AGENDA
HISTORIC DISTRICT COUNCIL
REGULAR MEETING -VIRTUAL
THURSDAY, SEPTEMBER 17, 2020
5:00 PM
CITY HALL COMMISSION CHAMBERS
204 ASH STREET
FERNANDINA BEACH, FL 32034

- 1. CALL TO ORDER / ROLL CALL / DETERMINATION OF QUORUM**
- 2. APPROVAL OF MEETING MINUTES**
- 3. OLD BUSINESS**
 - 3.1 HDC 2019-37 - MARK AKINS, RICE ARCHITECTS, AGENT FOR FIRST PRESBYTERIAN CHURCH OF FERNANDINA BEACH, 515 CENTRE STREET**
Certificate of Approval (COA) to renovate the south and east elevations and add a rooftop terrace with canopy. *(Quasi-Judicial)*

Owner/Applicant:	Rice Architect, agent for First Presbyterian Church Fernandina Beach
Property Address:	515 Centre Street
Requested action:	Certificate of Approval (COA) to renovate the south and east elevations and add a rooftop terrace with canopy.
Current zoning:	C-3
FLUM land use category:	Central Business District
Existing uses on the site:	Commercial
FL Master Site File #	8NA01098
Year Built:	1957 (FMSF)
Contributing Status:	Non-Contributing

961687 Gateway Blvd, Suite 201 H, Amelia Island, FL 32034

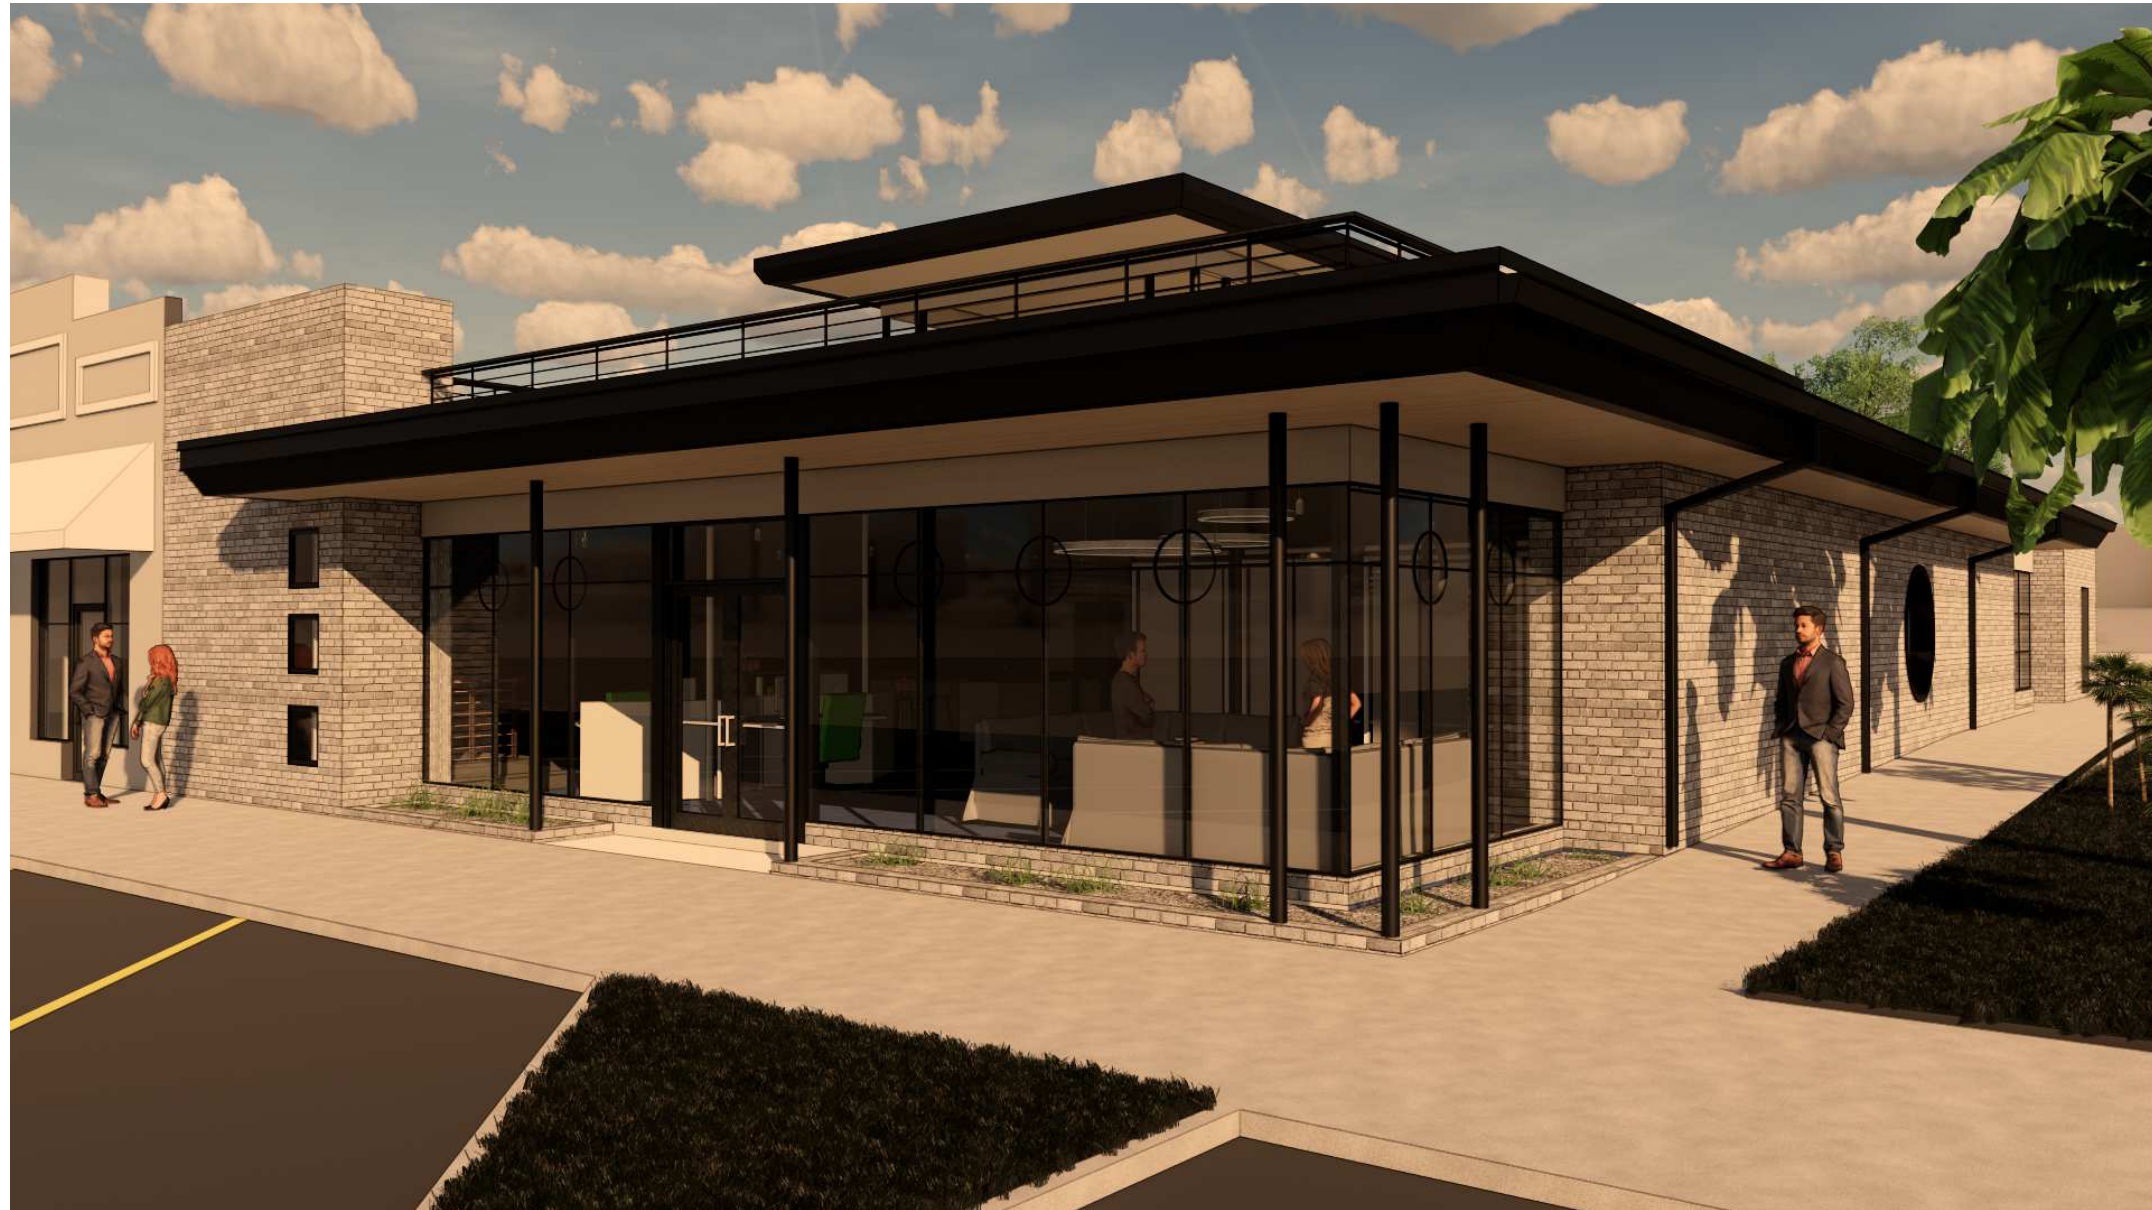
Staff is concerned that the level of alterations being proposed undermine the structures historic integrity. Many elements are being added to the structure which do not have any basis in the original design, which featured simple lines and emphasis on the horizontality. Utilizing the rooftop is allowable, but the proposed canopy does not relate to the architecture of the building and will be highly visible from multiple sides of the building. As designed, the rooftop canopy will be a visual detractor to the building and the district as a whole.

1. Elimination of the reflecting pond and railings at front entrance;
2. Reduction to the number of circular windows on the east elevation from three to one larger one;
3. Change in roof form of rooftop canopy from hipped to flat roof; and
4. Change in rooftop railing design.

A1.0

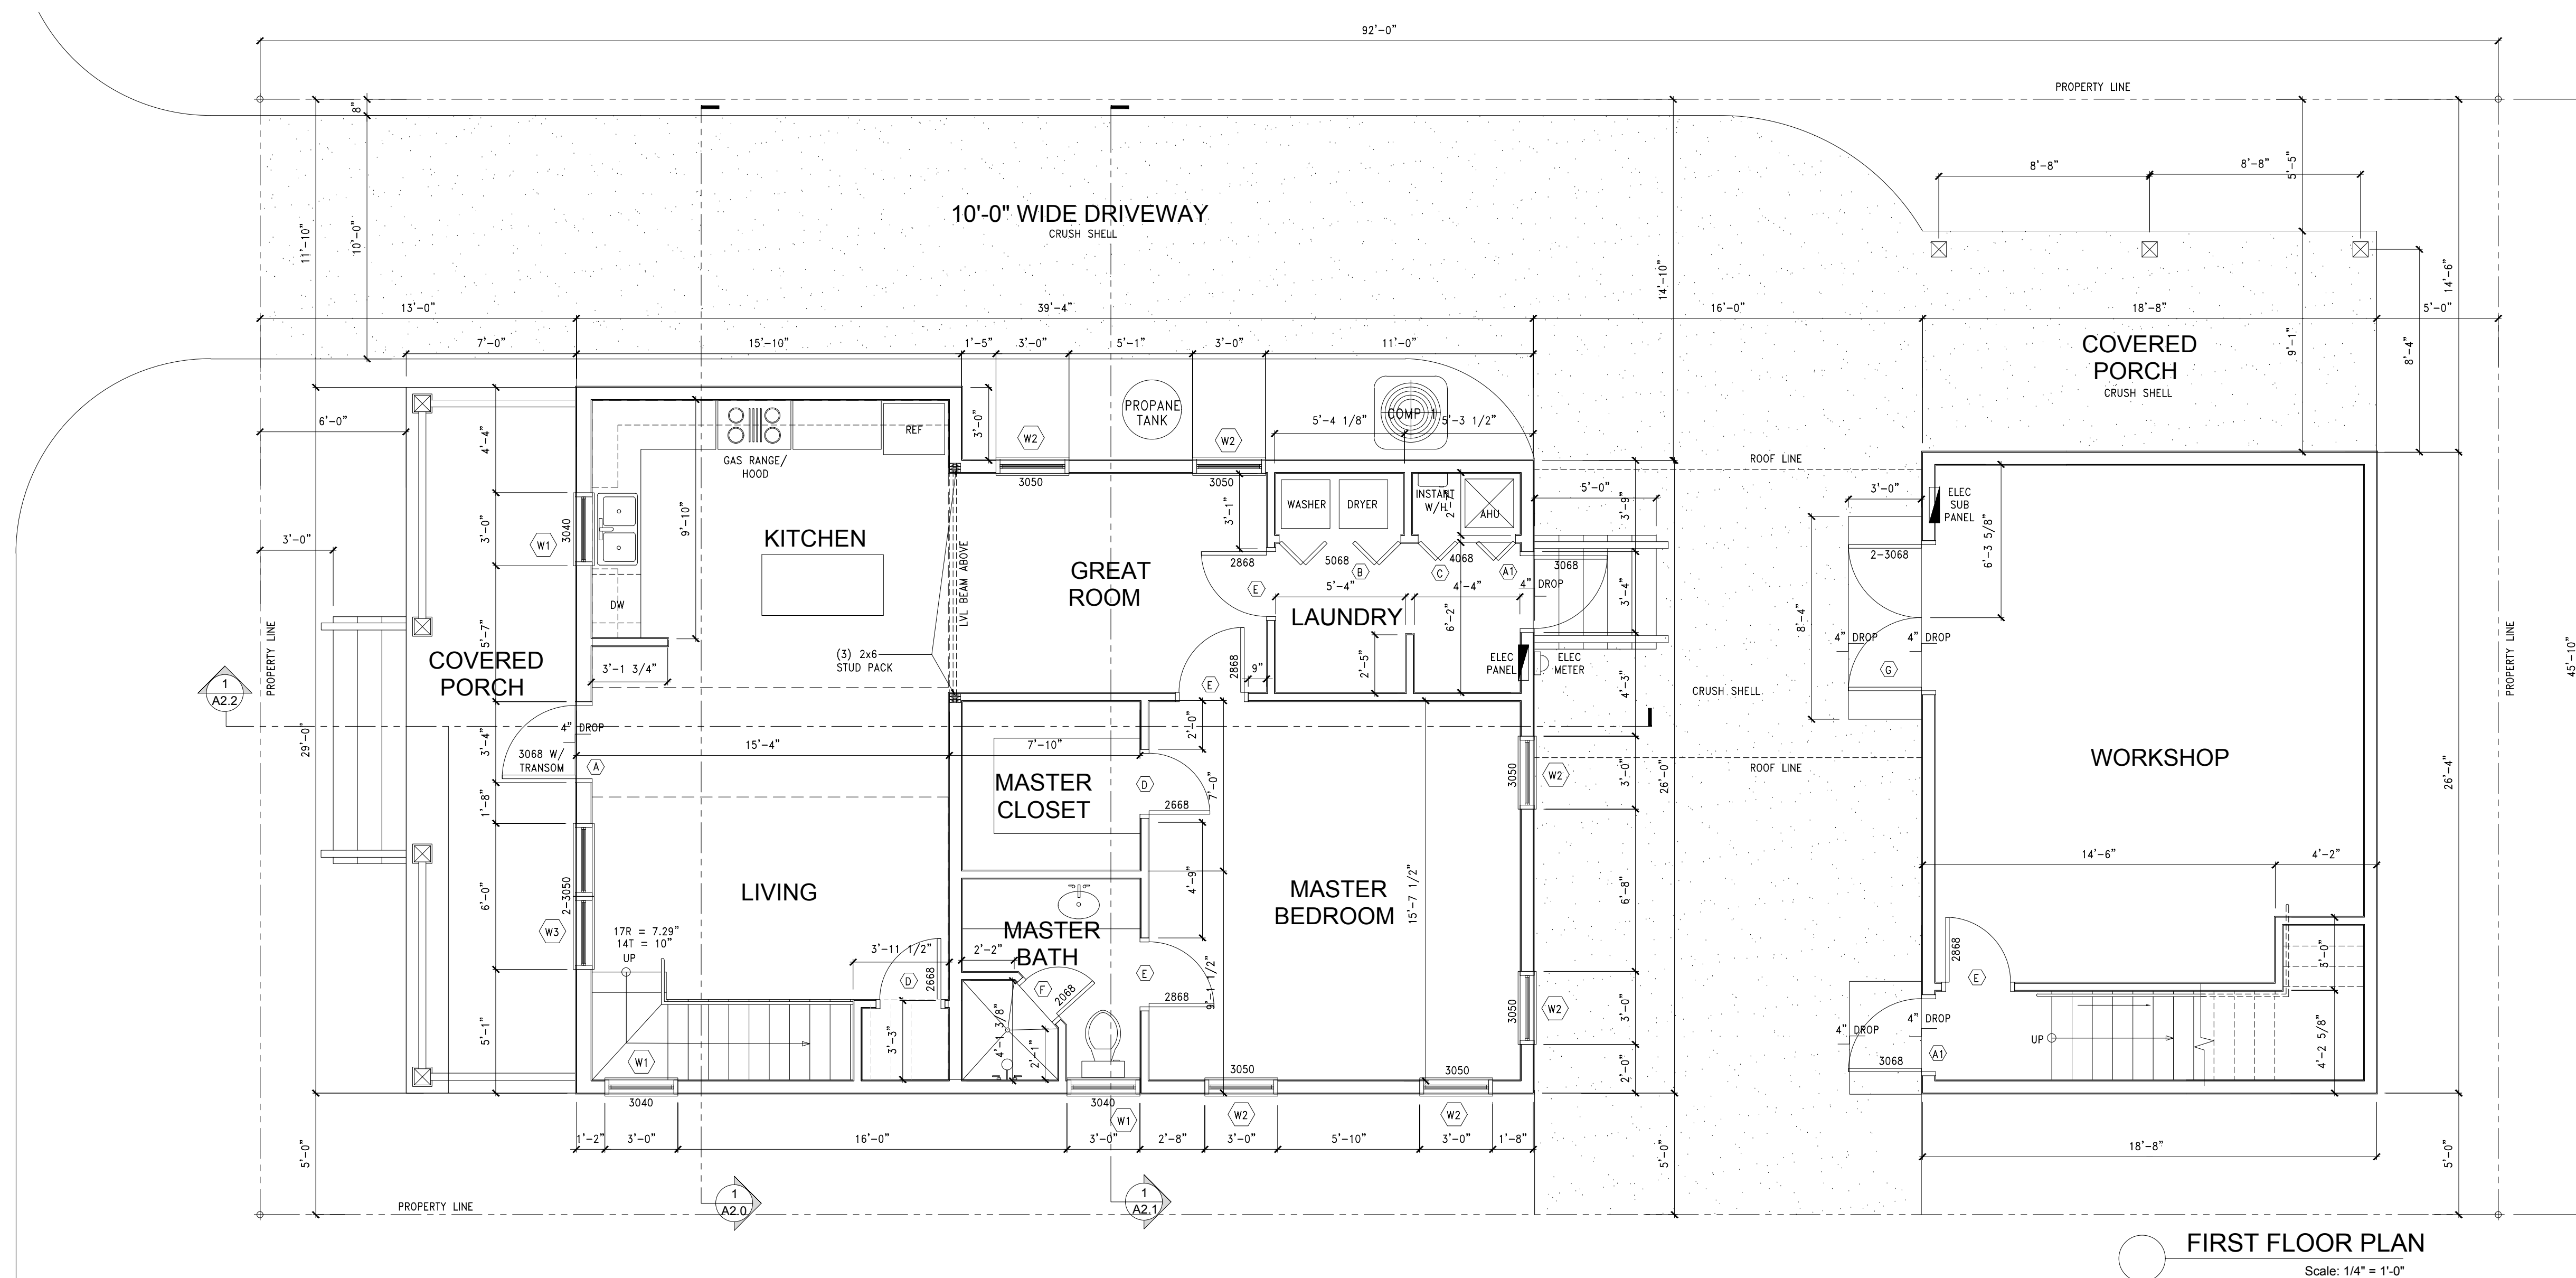
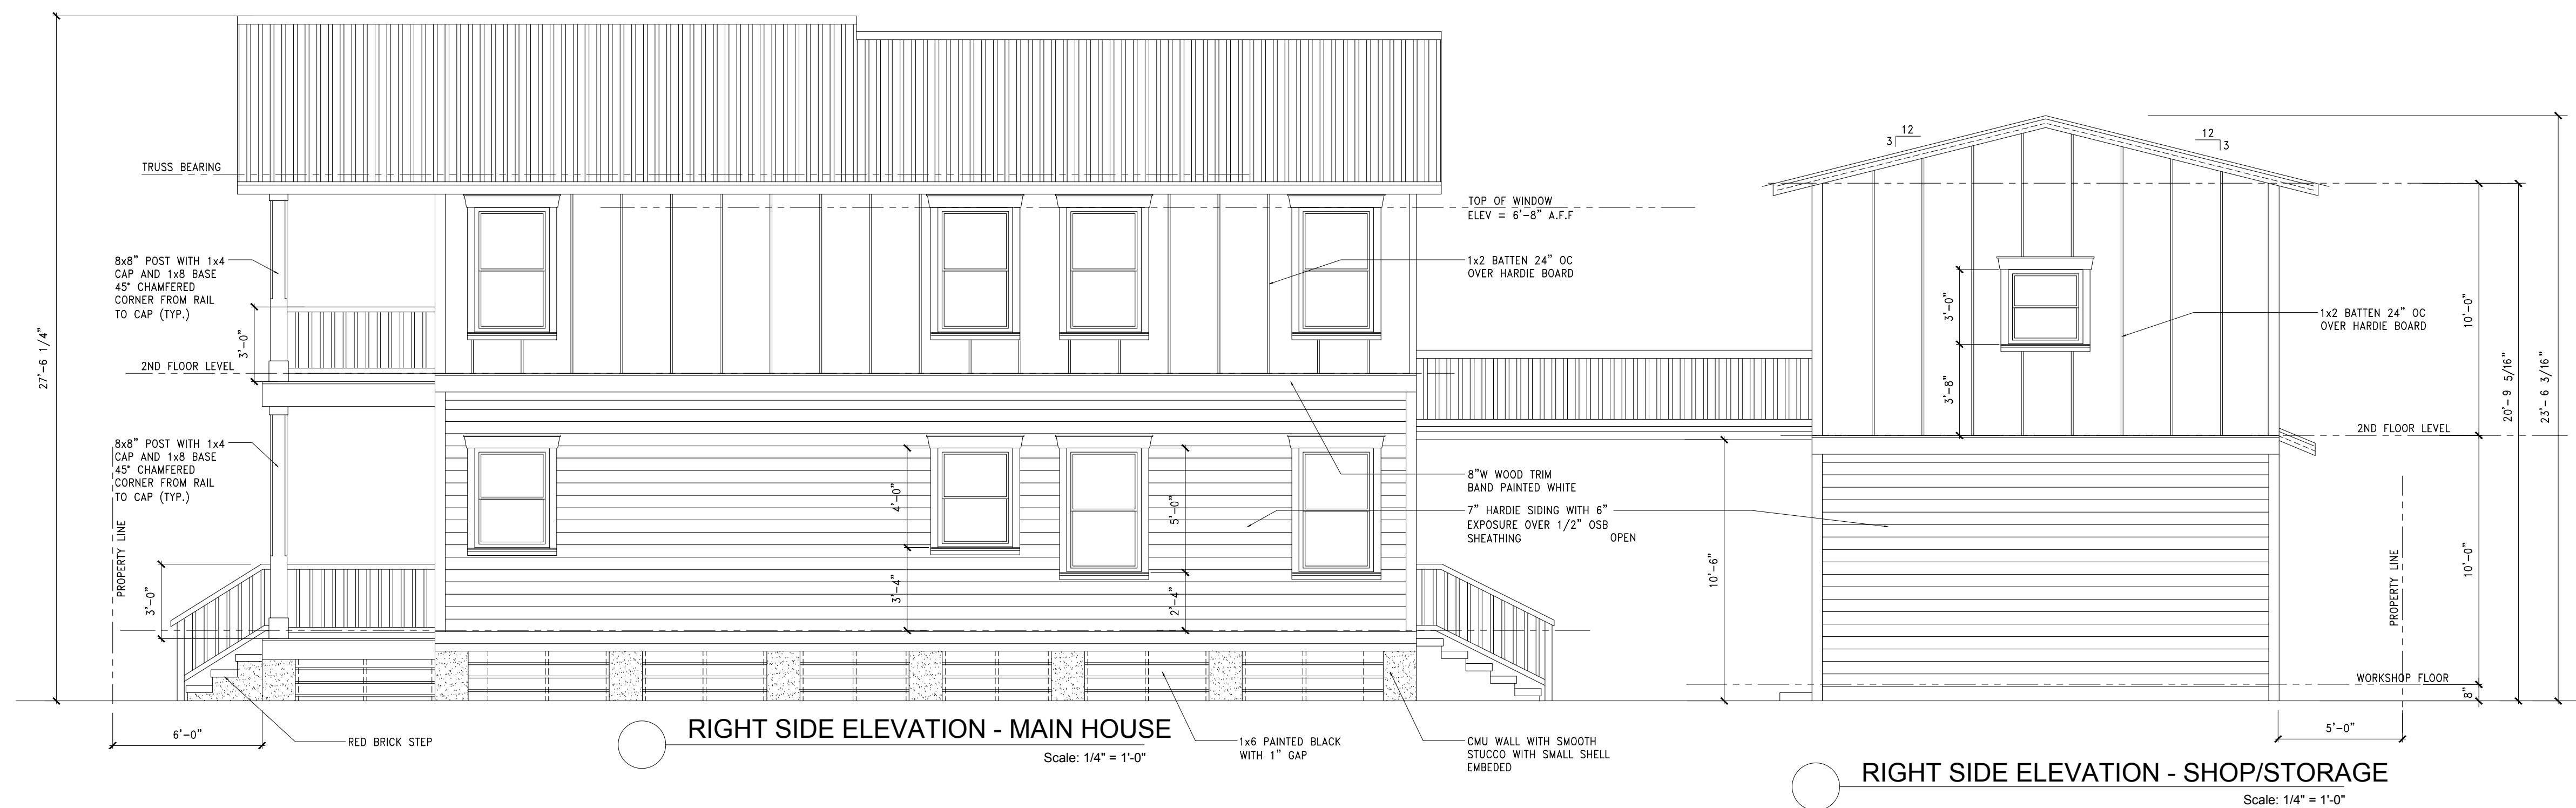
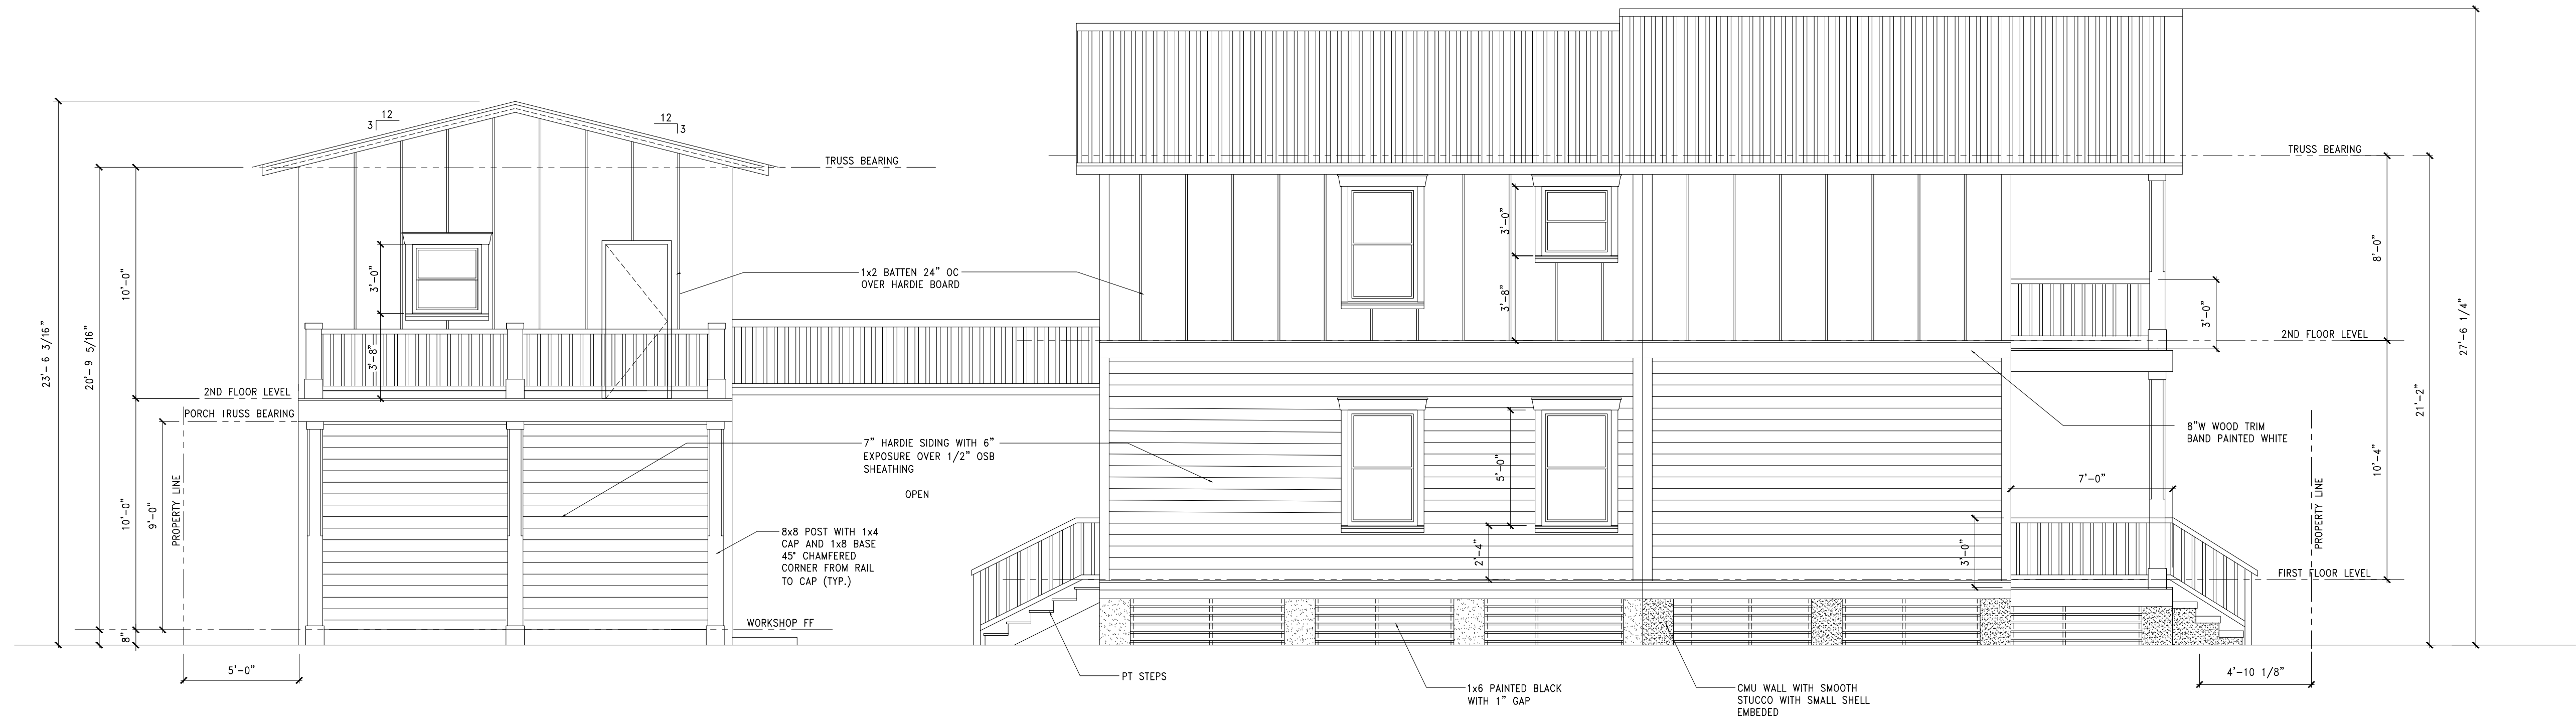
1. altering the roof pitch to bring the roof height down to 24';
2. moving door on east side elevation to the second floor;
3. removing ground floor window on west elevation;
4. adding window at second floor of east elevation; and
5. change carport to second floor deck.

At a current height of 25' 1", the accessory structure is above the permissible height. The requested modification to the roof pitch would bring the structure into compliance.

All other modifications requested do not have a negative impact on the project and meet all LDC and Design Guidelines.
